**EPA REGION 6 ANNOUNCES THE COMPLETION OF THE DRAFT FINAL
REMEDY SYSTEM EVALUATION (RSE) REPORT**

**HOMESTAKE MINING COMPANY SUPERFUND SITE
CIBOLA COUNTY, NEW MEXICO**

RE: Transmittal of Draft Final Remediation System Evaluation for the Homestake Mining Company

FIGURE 4.3-78. SELENIUM CONCENTRATIONS FOR WELLS K4, K7, K9 AND K10.

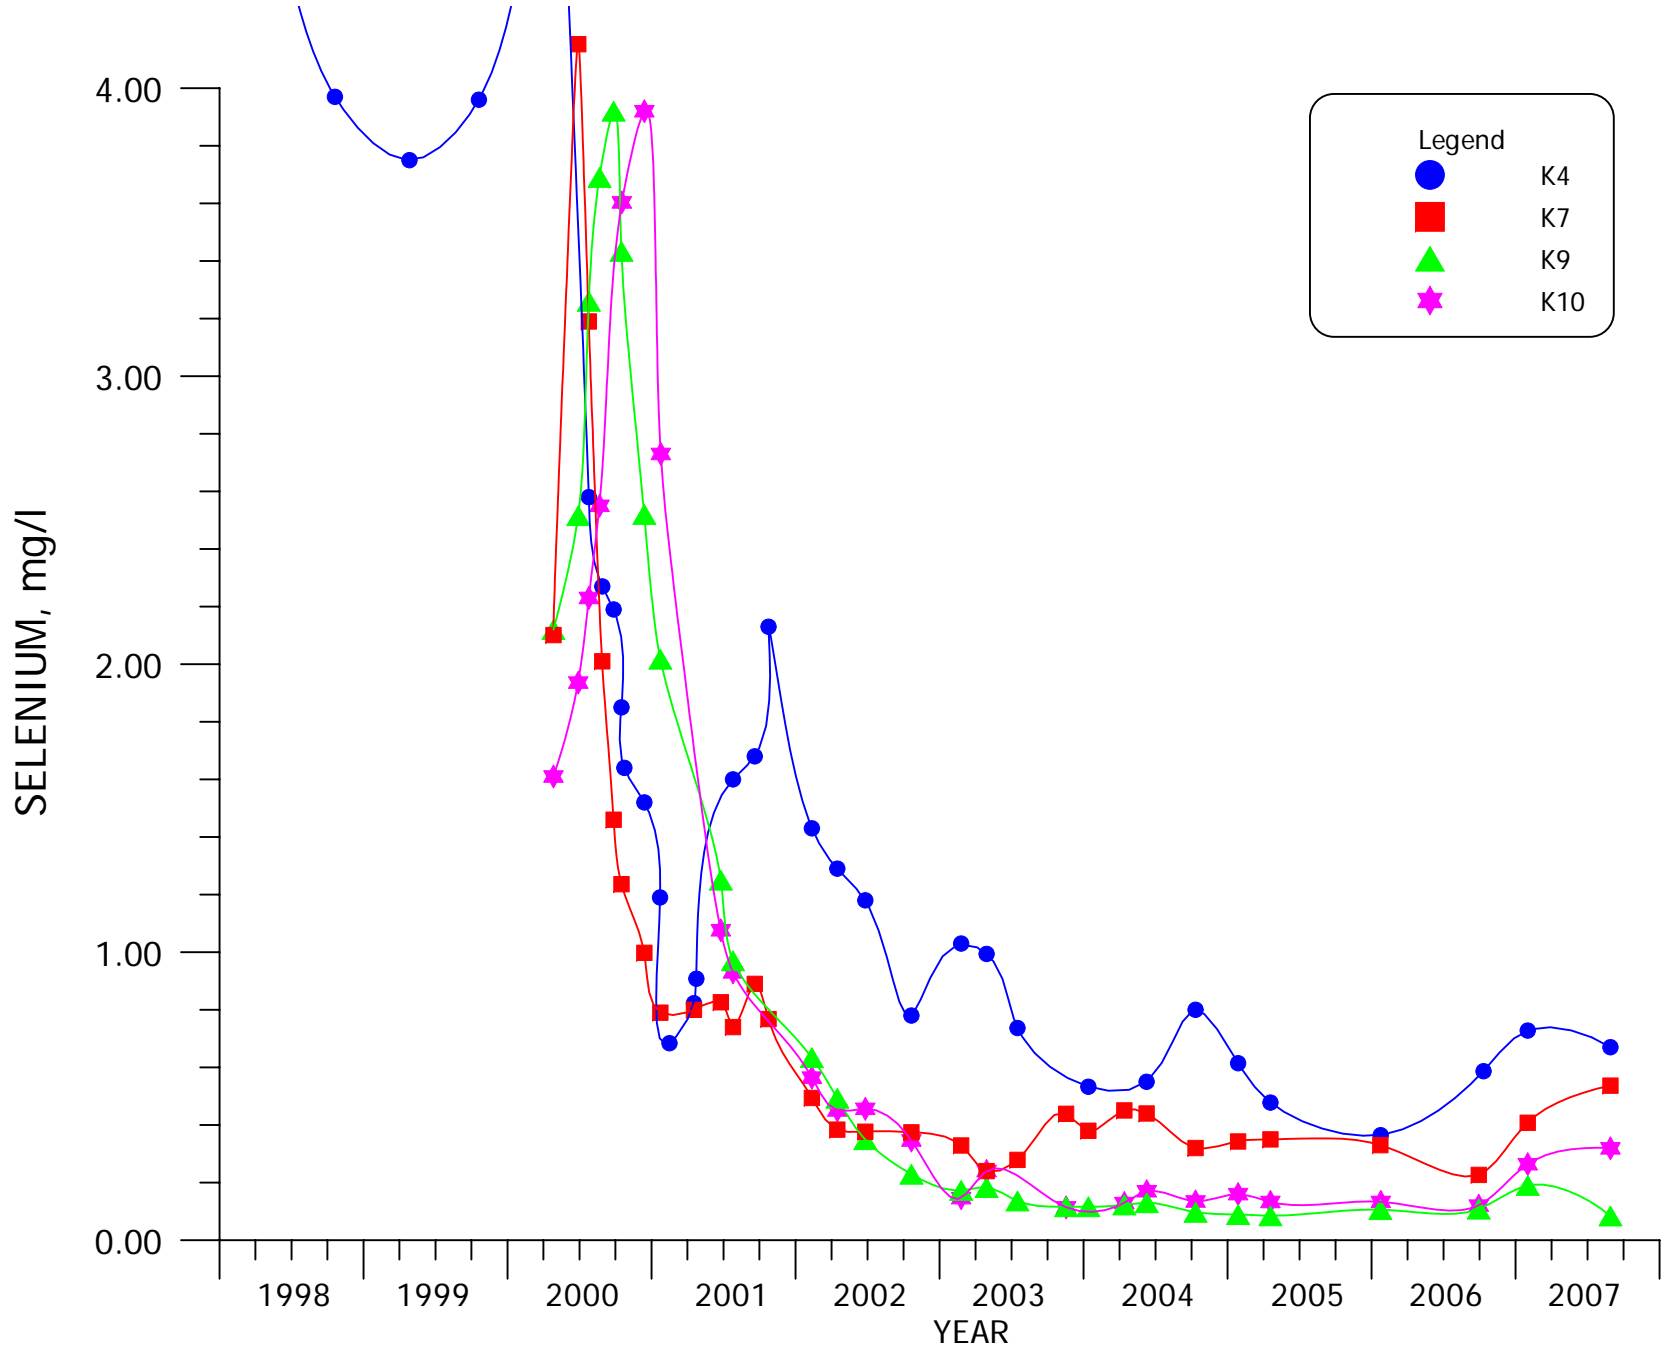
20	<p>Section 1.5.3.1, page 8. The last two sentences of this section refer to Figures 4.3-78 and 4.3-83 and state that the figures show decreases in uranium concentrations. Please revise “uranium” to “selenium” in these sentences. It appears that Well 851 has shown increased Se concentration in 2006 and 2007 and revise the last sentence accordingly</p> <p><u>Response:</u> Agree. Corrections will be made.</p>	EPA (USACE Hearty)
21	<p>Page 10, Section 1.5.4: Suggest that the document provide quantitative evaluations of soil contamination due to crop irrigation with contaminated groundwater and bioaccumulation in livestock due to feeding with hay irrigated with contaminated groundwater.</p> <p><u>Response:</u> Agree, however, no information was available to the RSE Team to provide quantitative evaluations with regard to soil contamination or bioaccumulation of metals associated with the irrigation program.</p>	EPA (USACE Mao)

FIGURE 6.3-14. SELENIUM CONCENTRATIONS OF THE MIDDLE CHINLE AQUIFER, 2007, mg/l

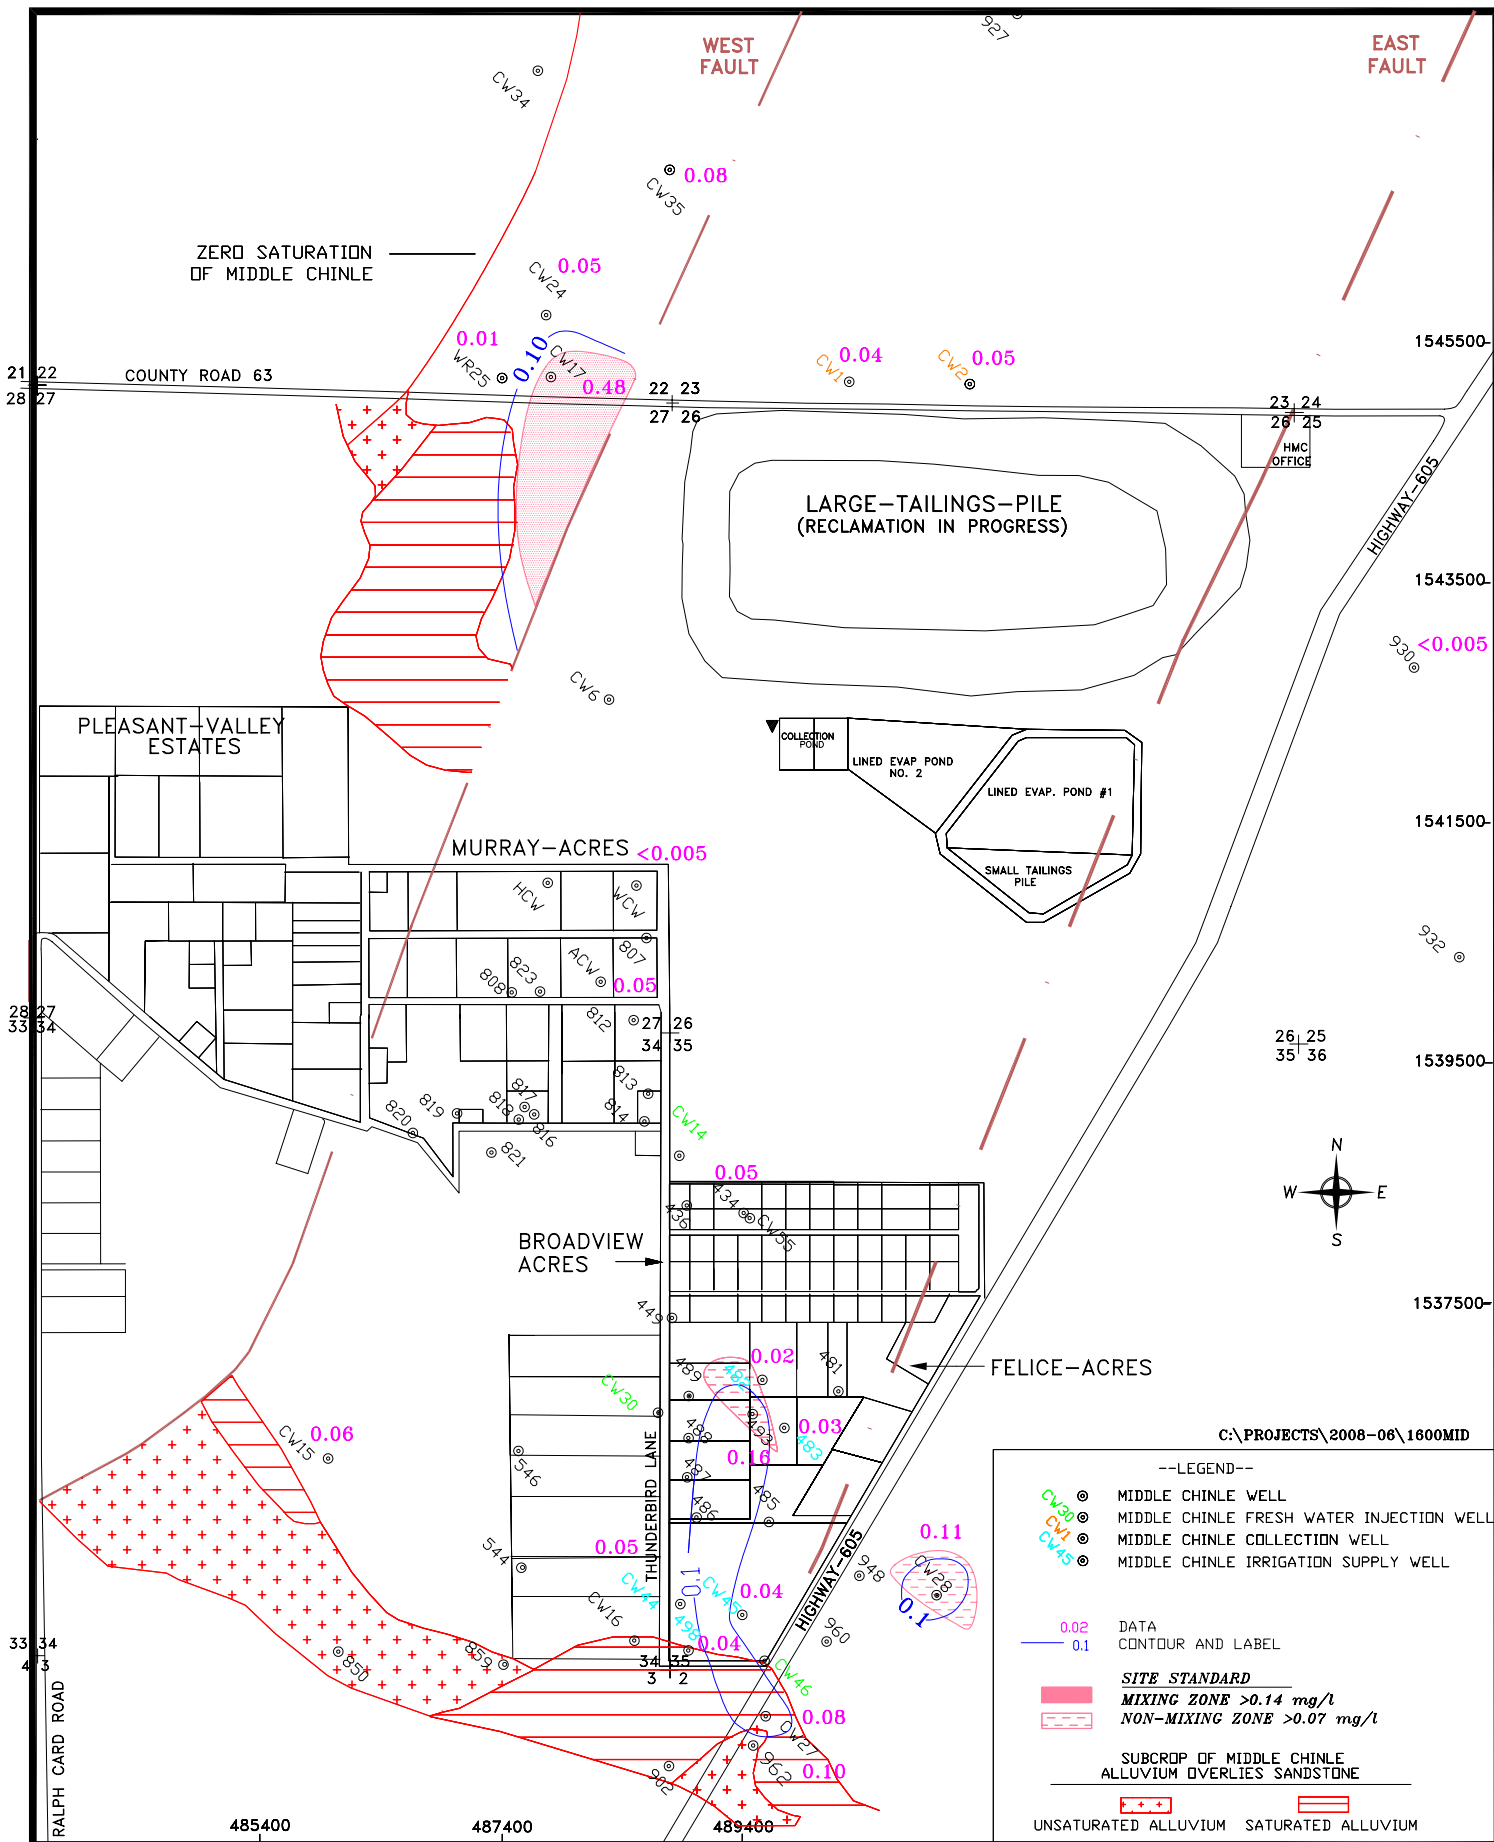
<p>Felice Acres is detached from the main plume (Figure 4.3-53), what transport mechanisms caused impacts in the Middle Chinle (Figure 6.3-14) and Lower Chinle (Figure 7.3-8) aquifers. These issues could result in a revised CSM.</p> <p><u>Response:</u> Agree. Language will be added throughout the Final Report to better describe the mechanisms by which the Chinle Aquifers are contaminated. Note that Figure 4.3-35 does not depict a detachment of the plume but demonstrates where the plume concentration is below the NRC action level (refer to Section 3.3).</p>	
3	<p>Consider alternatives for hydraulic control that may reduce evaporative demands. The current approach of injecting >1,000 gpm of San Andres aquifer water into the alluvial aquifer (for hydraulic control) likely adds a significant amount to the evaporative demand at the site (b/c it is assumed that some injected water is recaptured by the extraction wells and eventually sent to the evaporation ponds). Since one of the limiting factors at the site is evaporation capacity, it may be worthwhile to look at reducing the San Andres injection flow rate and using extraction wells alone (or other capture techniques) rather than injection/hydraulic mounding to achieve capture. The trade off of the two approaches can be evaluated using formal hydraulic and or transport optimization techniques such as MODMAN (see epa.gov/optimization for more information) or through manual approaches using flow and transport modeling without mathematical optimization. This process may “free up” evaporative capacity of the current system.</p> <p><u>Response:</u> The use of San Andres Aquifer water does not significantly affect the evaporative demands of the site. The primary source of water going to the evaporation ponds (71% or 121 gpm) is the Large Tailings Pile flushing program. The remaining 29% (49 gpm) going to the evaporation ponds comes from the Alluvial Aquifer after RO treatment. This water is primarily re-injected Alluvial Aquifer water and Chinle Aquifers water. This amount is only 4% of the total amount of San Andres Aquifer water being pumped into the Alluvial Aquifer for hydraulic control.</p> <p>It is agreed that independent modeling might assist evaluation of alternative pumping approaches. The effort necessary to conduct independent modeling involves a robust approach involving multiple aquifers including vertical communication between the aquifers. Independent modeling was not a part of this RSE.</p>	EPA (Yager)
